COTTAGE GROVE PLANNING COMMISSION

STAFF REPORT CASE: CP/ZA/PUD/PP2024-015

REQUEST: A Comprehensive Plan Amendment, Preliminary Plat, Rezoning, and a Planned Unit Development (PUD) for a project to be known as Preserve at Prairie Dunes that would consist of 162 single-family homes on approximately 60 acres.

Planning Staff Report
Preserve at Prairie Dunes
Planning Case Nos. ZA2024-015, PP2024-015,
PUD2024-015 & CP2024-015
July 22, 2024

OVERALL PRELIMINARY
GRADING DRAINAGE &
EROSION CONTROL PLAN
PROJECT NUMBER: 0032908.00

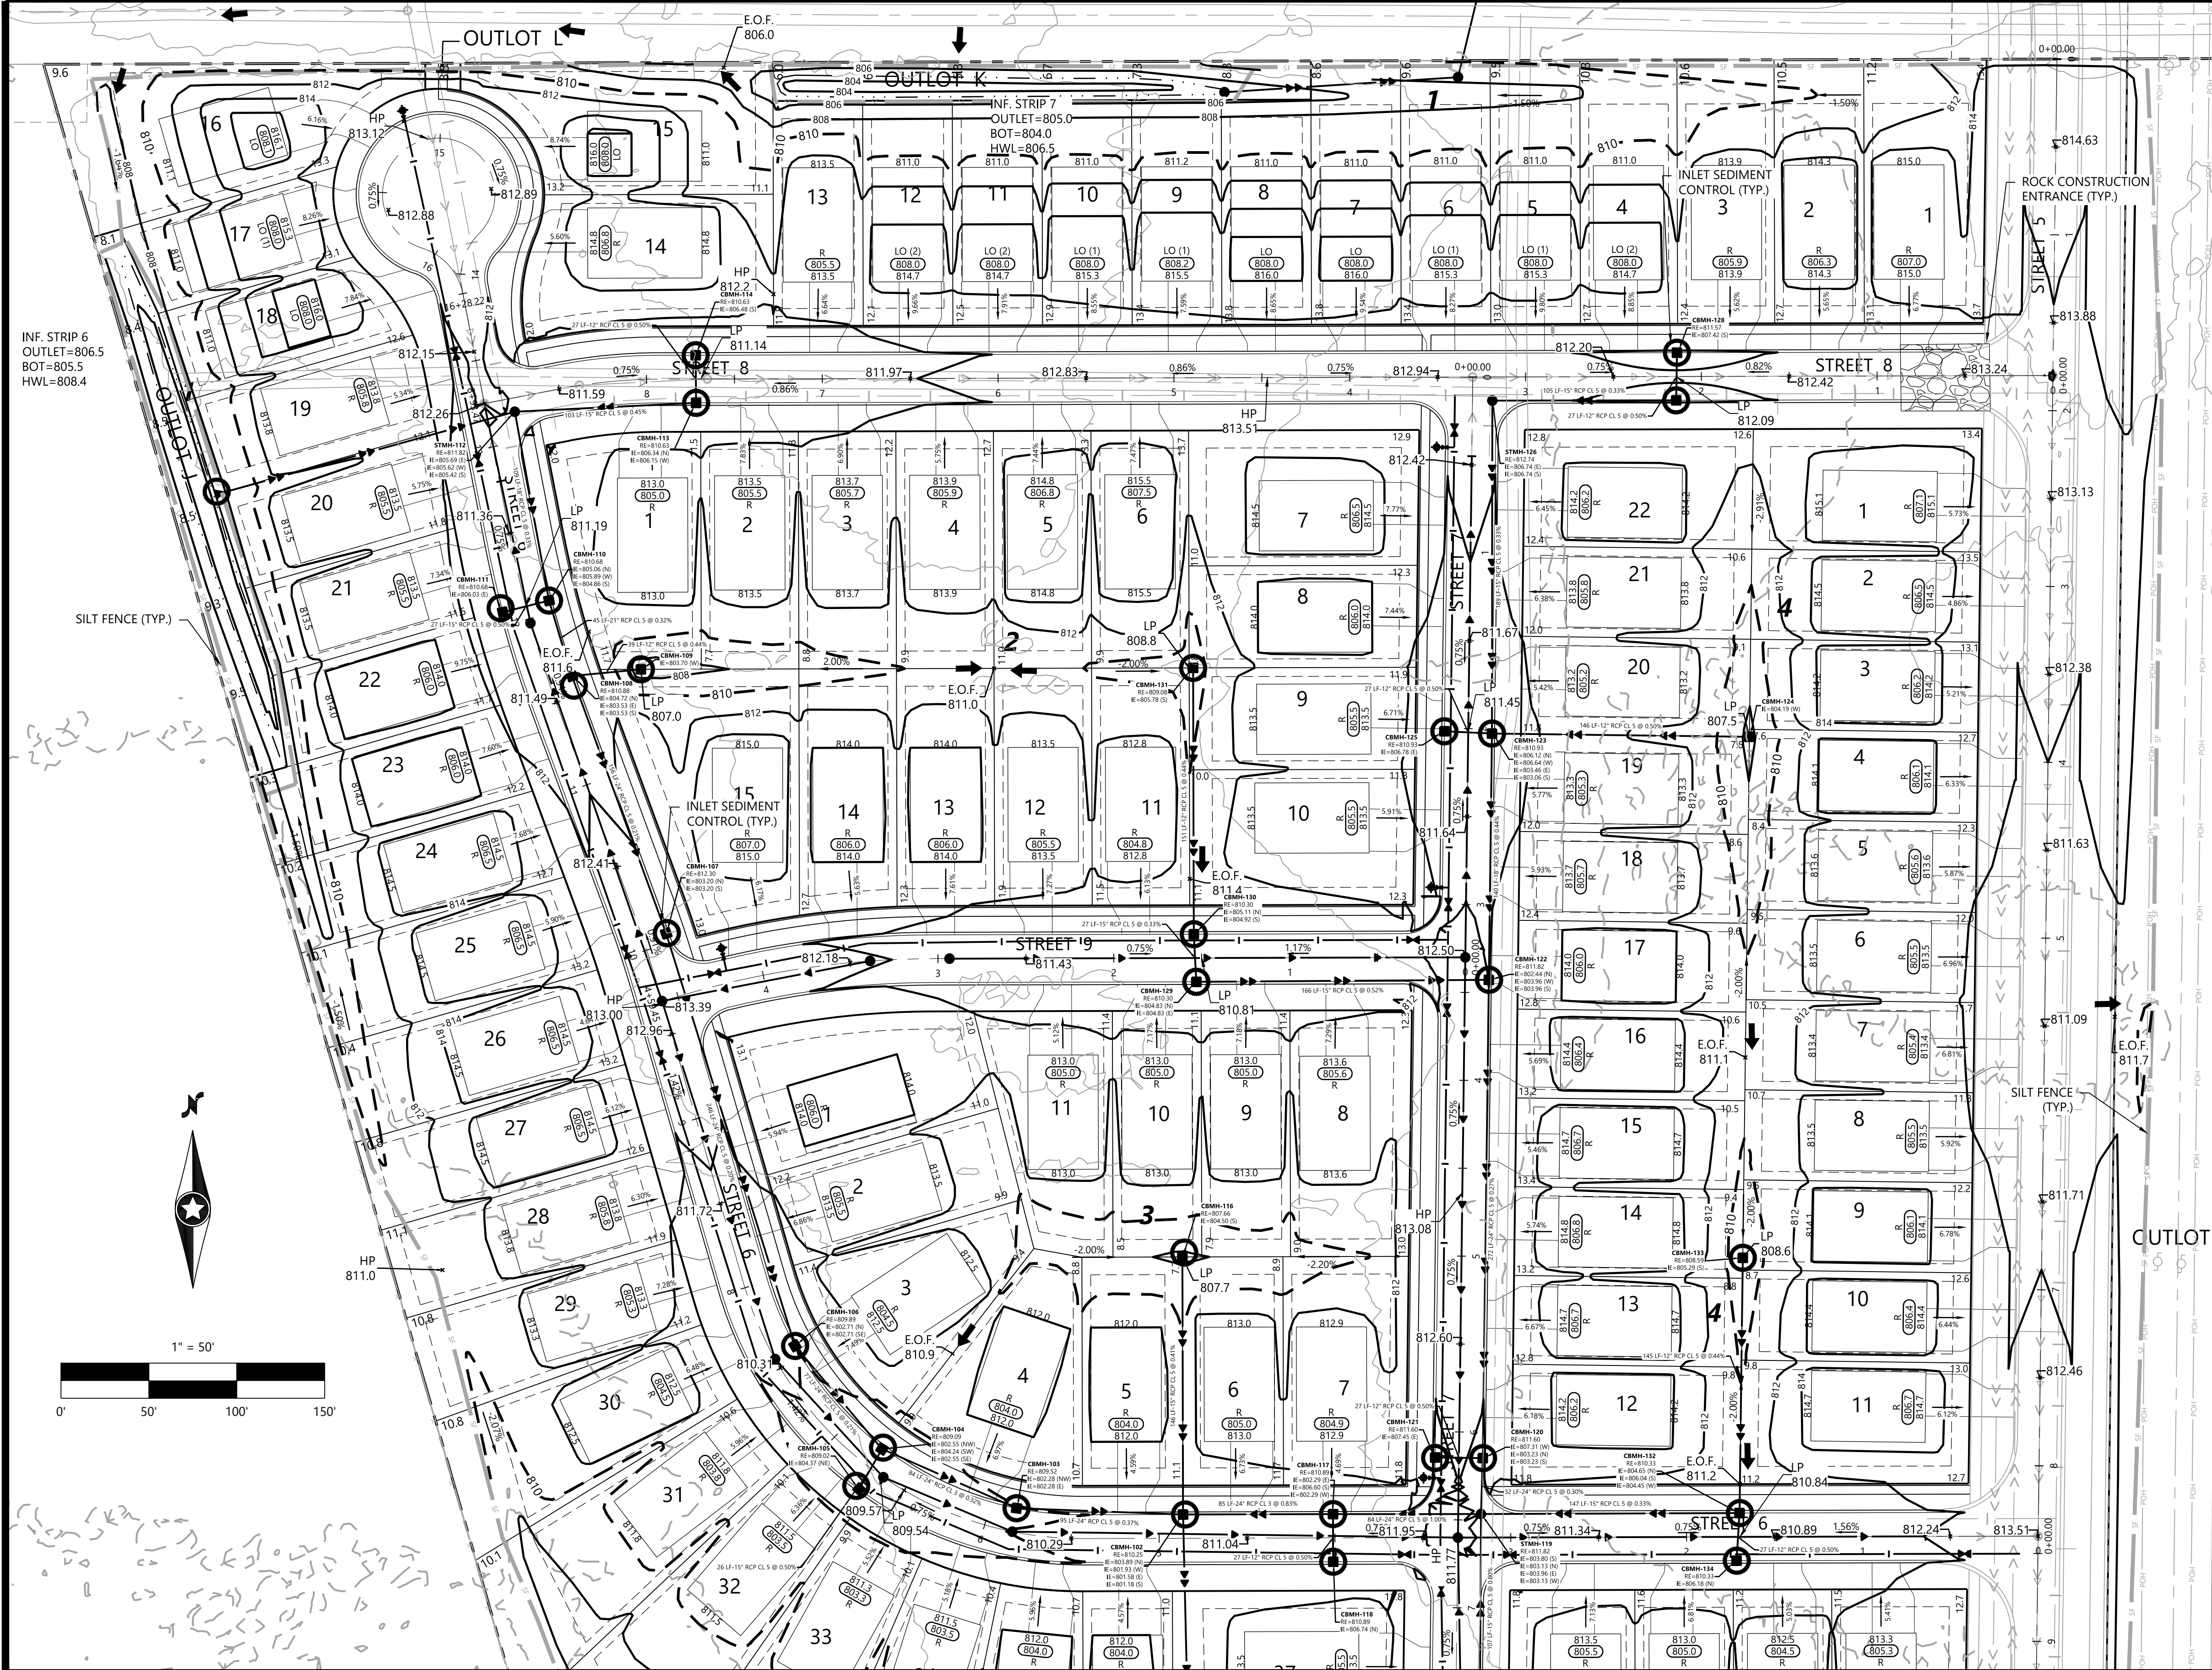
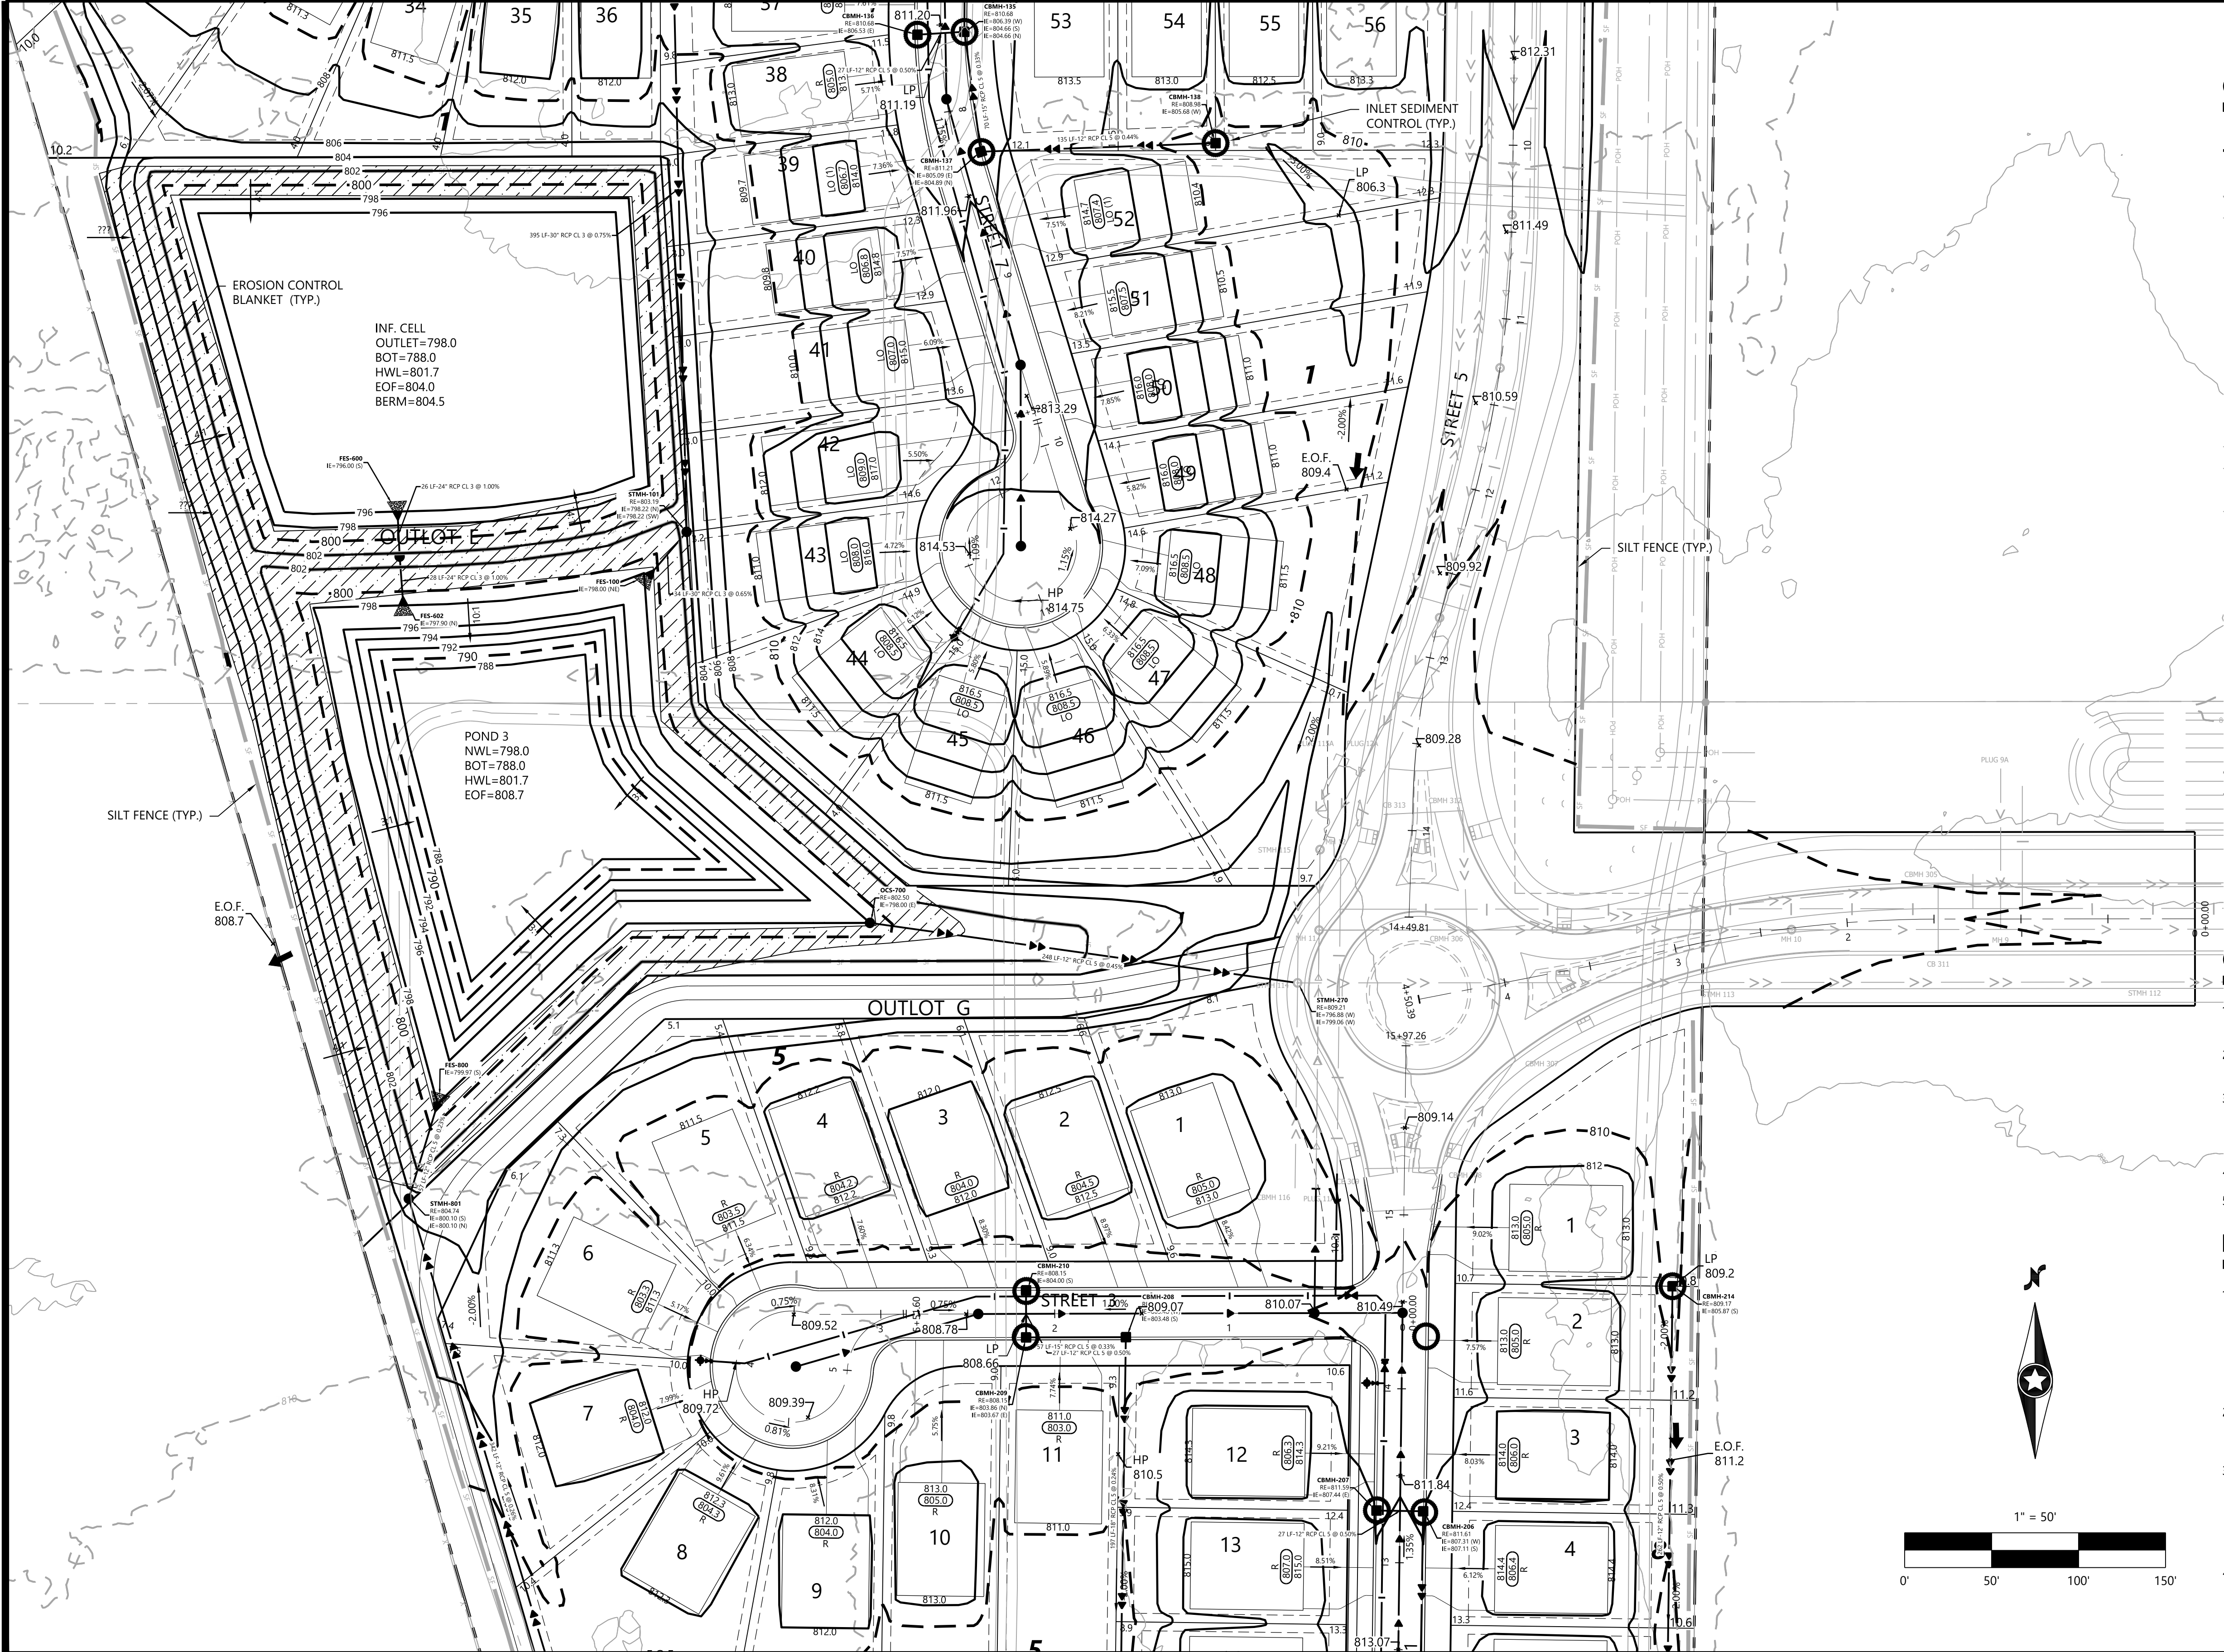
Preliminary Grading Plan Comments (sheets 9 - 13):
